DEVELOPMENT REVIEW BOARD MEETING

- 3. Resolution No. 403: Black Creek Group Industrial Project: Lee Leighton, AICP, Mackenzie – Representative For BTC III Grahams Ferry IC LLC – Applicant and Gary S. Rychlick As Trustee of the Eileen Rychlick Trust and individually, and Susan M. Rychlick – Owners. The applicant is requesting approval of a Stage 1 Preliminary Plan, Stage 2 Final Plan, Site Design Review, Waivers, Class 3 Sign Permit and Type C Tree Removal Plan for development of a 148,279-square-foot warehouse / manufacturing building with accessory office space located between SW Grahams Ferry Road and SW Garden Acres Road. The subject site is located at 25020 and 25190 SW Grahams Ferry Road on Tax Lot 100 of Section 3D, Township 3 South, Range 1 West, Willamette Meridian, Washington County, Oregon. Staff: Cindy Luxhoj, AICP, Associate Planner**

**DEVELOPMENT REVIEW BOARD
RESOLUTION NO. 403**

Exhibit A1
Staff Report
Wilsonville Planning Division
Black Creek Group Industrial

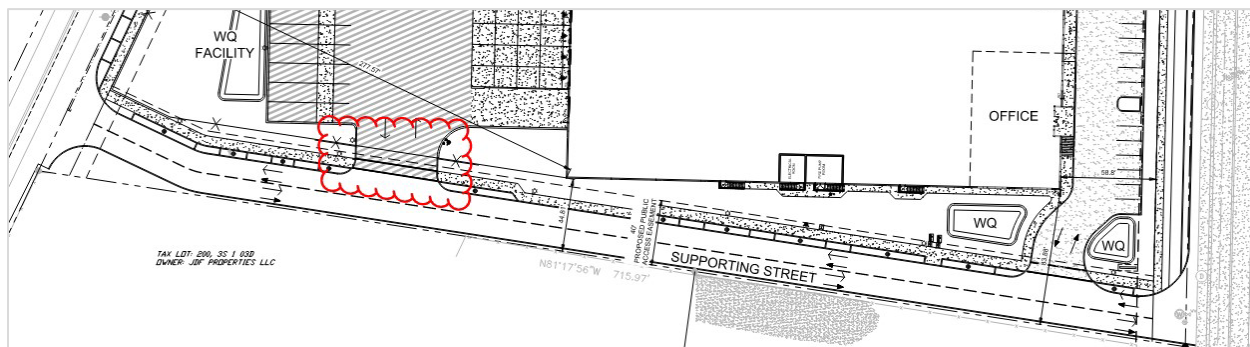
D1. The applicant requests to waive the parcel driveway width standards from the Coffee Creek Design Overlay District for the southwestern site access. Of the two driveways proposed on the southern side of the site, the southwestern driveway is proposed to be 50 feet wide to accommodate vehicle turning movements into the site from the Supporting Street. This requires a waiver from Subsection 4.134 (.11) Table CC-3 1. Parcel Access/Parcel Driveway Width/Supporting Streets, which allows a driveway width of 24 feet maximum or compliance with the Supporting Street standards. The applicant states the rationale for requesting this waiver as summarized below:

- a. The 50-foot-wide southwestern driveway is necessary to accommodate frequent semi-tractor-trailer ingress/egress without movement conflicts, allowing efficient, simultaneous circulation.
- b. A wider driveway could be accommodated along an Addressing Street, but at this location both SW Grahams Ferry Road and SW Garden Acres Road are subject to access spacing requirements that do not allow a driveway on either segment. Extensive site plan alternatives analysis and discussion with Wilsonville Planning and Engineering staff led to the proposed access plan.

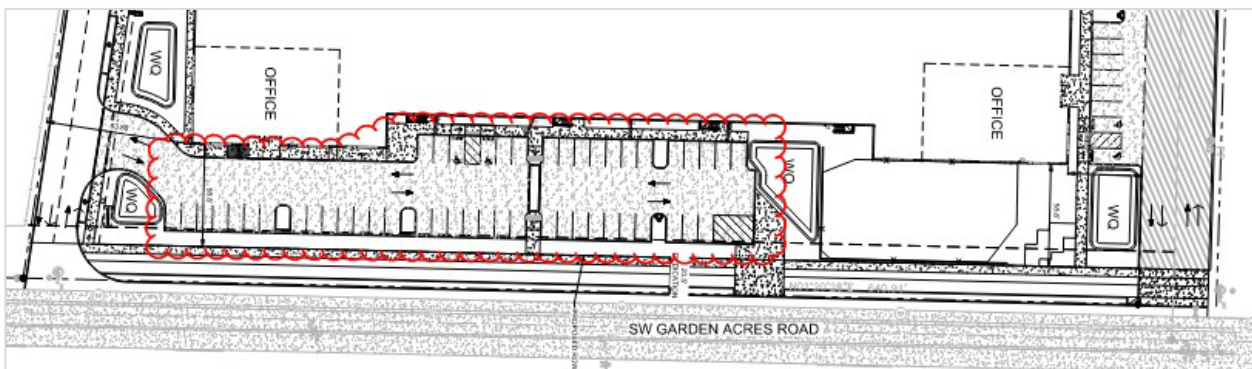
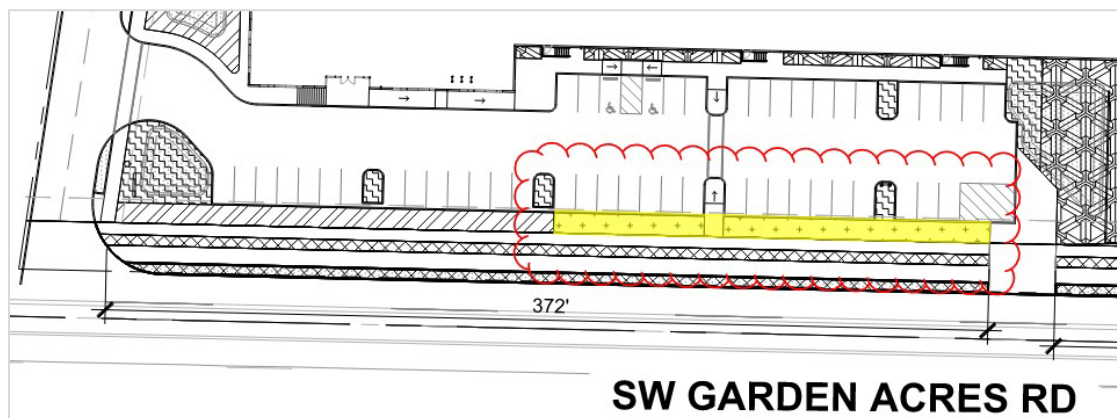
- D3.** The applicant requests to waive the vehicle parking area design standards from the Coffee Creek Design Overlay District. Subsection 4.134 (.11) Table CC-3 4. Parking Location and Design/General/Addressing Streets, and Parking Location and Extent/Addressing Streets allows 16 spaces maximum with an adjustment to 20 spaces on an Addressing Street. This parking is limited to one double-loaded bay to be designated for short-term (1 hour or less), visitor, and disabled parking only between the right-of-way of the Addressing Street and building. This standard is listed as one of three in Section 4.134(.08) Waivers that shall not be waived unless there is substantial evidence in the whole record to support a finding that the intent and purpose of the standard will be met in alternative ways. The applicant proposes to locate the majority (49 of 71 spaces) of provided parking between the right-of-way of SW Garden Acres Road, an Addressing Street, and the front of the building. In addition, the applicant proposes to use the spaces for employee parking, as well as the permitted uses of short-term, visitor, and disabled parking.

- a. The site is unique in that it has double-frontage on Addressing Streets SW Garden Acres Road and SW Grahams Ferry Road, which are Minor Arterial streets with access spacing limitations that will not allow direct access driveways on either roadway. The limited options for site access significantly affect site design options.

- b. To meet other development standard requirements, the building must be sited and oriented with its long axis parallel to the Addressing Streets. This orientation limits the space available for parking and loading areas in “side yards” on the north and south sides of the building adjacent to the drive aisle and Supporting Street.
- c. To the extent it is feasible to do so, separation of heavy truck operations from employee and visitor parking is appropriate for safety and efficiency. The proposed site plan locates employee parking east and north of the building, and truck loading operations west of the building.

D4. Pursuant to Subsection 4.118 (.03) A., waivers must implement or better implement the purpose and objectives listed in this subsection. Subsection 4.134 (.08) requires substantial evidence in the whole record to support a finding that the intent and purpose of the standards will be met in alternative ways. As explained by the applicant in the narrative code response, the building requires as much north-south distance as possible to achieve an economically viable scale of operations, which results in the building’s long axis oriented north-south. Providing more parking than is proposed north and south of the building would conflict directly with achieving efficient site design for the intended industrial use. With truck parking and circulation on the west side of the building, lack of space for more parking than is proposed on the north side, and inability to locate parking on the south side, the east side of the building is the only location remaining for the majority of vehicle parking. To reduce visibility from the public right-of-way of the double-loaded bay of parking in the north half of this eastern parking area, consistent with the Pattern Book intent the applicant proposes landscaping to the high screen standard in the highlighted area shown in the illustration below. The applicant requests the waiver from the parking location and extent standard for flexibility in design in responding to the unique constraints of the site. The increased landscaping the applicant will install enables the purpose and objectives of the parking standards to be met.

Waiver 3: Vehicle Parking Setback on Addressing Street

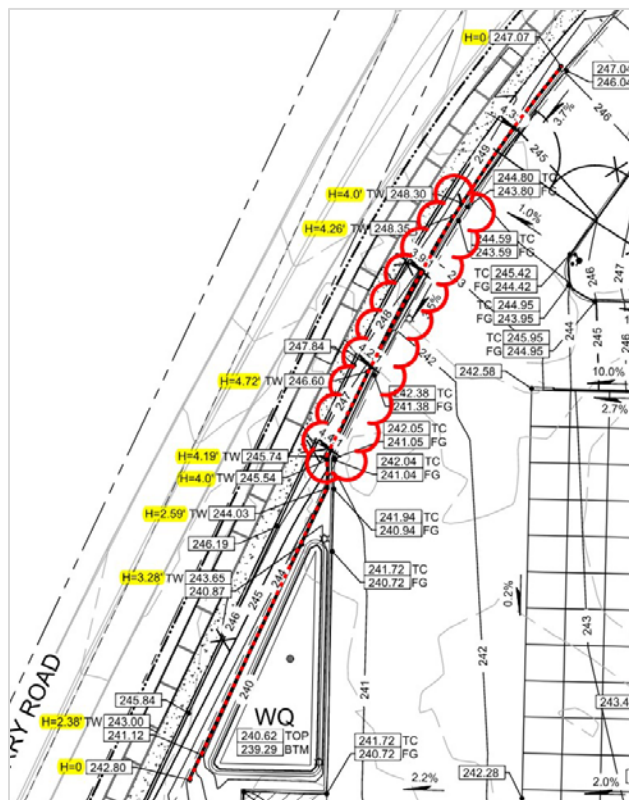
- D5.** The applicant requests to waive the vehicle parking setback standards from the Coffee Creek Design Overlay District. Subsection 4.134 (.11) Table CC-3 4. Parking Location and Design/Parking Setback/Addressing Streets requires a 20-foot-minimum setback of the vehicle parking area from the right-of-way on an Addressing Street. The applicant proposes a setback of nine (9) feet for the vehicle parking area on SW Garden Acres Road, an Addressing Street, which is 11 feet fewer than the required minimum.

- a. While it is desirable to provide adequate separation between the right-of-way and vehicle parking area for aesthetics and pedestrian scale, a deviation from the parking setback requirement is necessary to achieve a feasible development plan for this unique site.

Waiver 5: Location and Visibility of Utilities and Services on Addressing Street

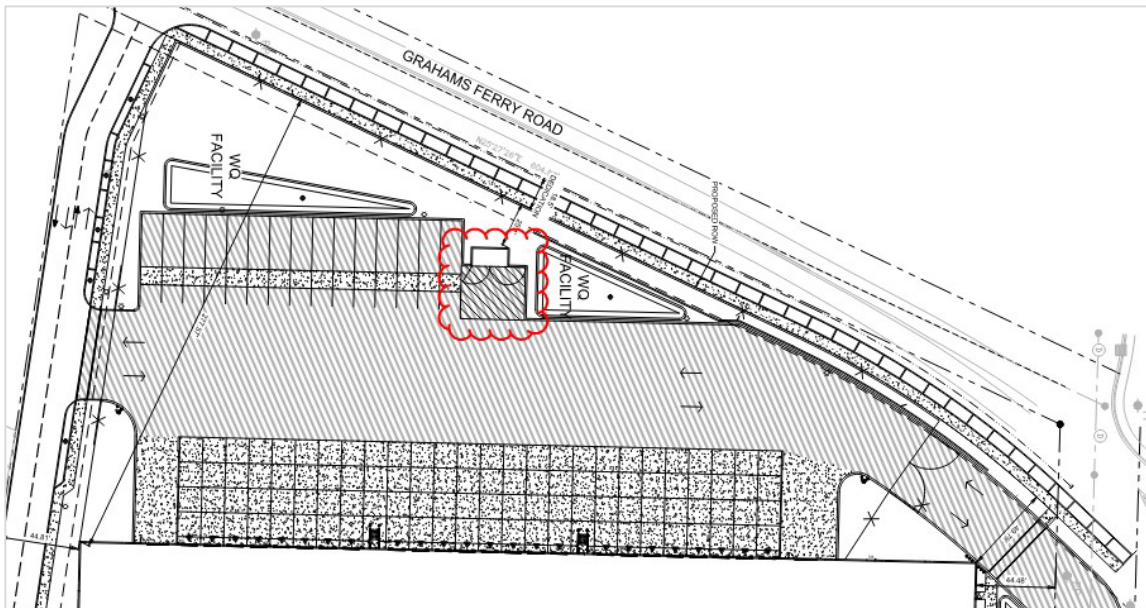
- D9.** The applicant requests to waive the location standard for mixed solid waste and recyclables storage from the Coffee Creek Design Overlay District. Subsection 4.134 (.11) Table CC-3 7. Location and Screening of Utilities and Services/Location and Visibility/Addressing Streets does not permit site and building service, equipment, and outdoor storage of garbage, recycling, or landscape maintenance tools and equipment on an Addressing Street. The applicant proposes to locate the trash/recycling enclosure on the western boundary of the site, adjacent to the SW Grahams Ferry Road right-of-way, requiring a waiver to the location standard.

- D10.** Pursuant to Subsection 4.118 (.03) A., waivers must implement or better implement the purpose and objectives listed in this subsection. Flexibility with respect to location of the trash/recycling enclosure allows it to be efficiently positioned on the west side of the building at the north end of the truck maneuvering court by the loading docks, where there is sufficient width for collection vehicles to operate. The applicant requests the waiver of the location standard for flexibility to allow a trash/recycling storage area configuration that enables efficient, practical, and safe function of the site and building for its intended industrial use.

Waiver 6: Primary Building Entrance/Accessible Entrance and Required Canopy

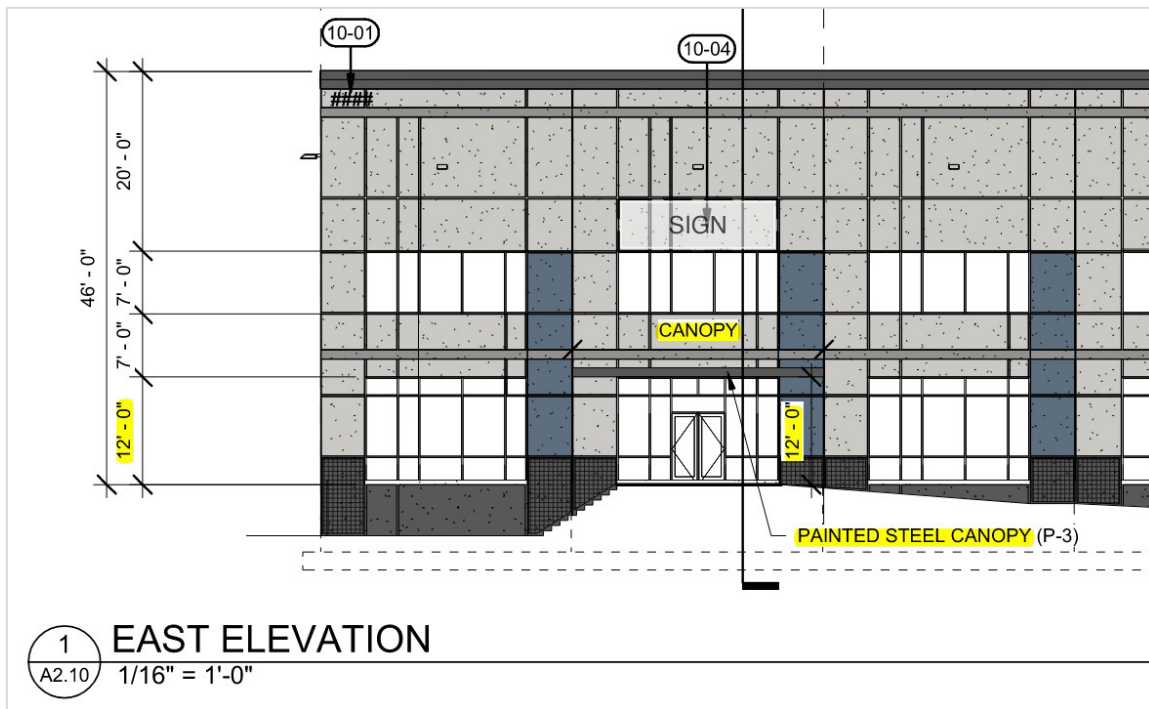
- D11.** The applicant requests to waive the required building entrance and canopy height from the Coffee Creek Design Overlay District. Section 4.134(.11) Table CC-4 2. Primary Building Entrance/Accessible Entrance and Required Canopy requires that the primary building
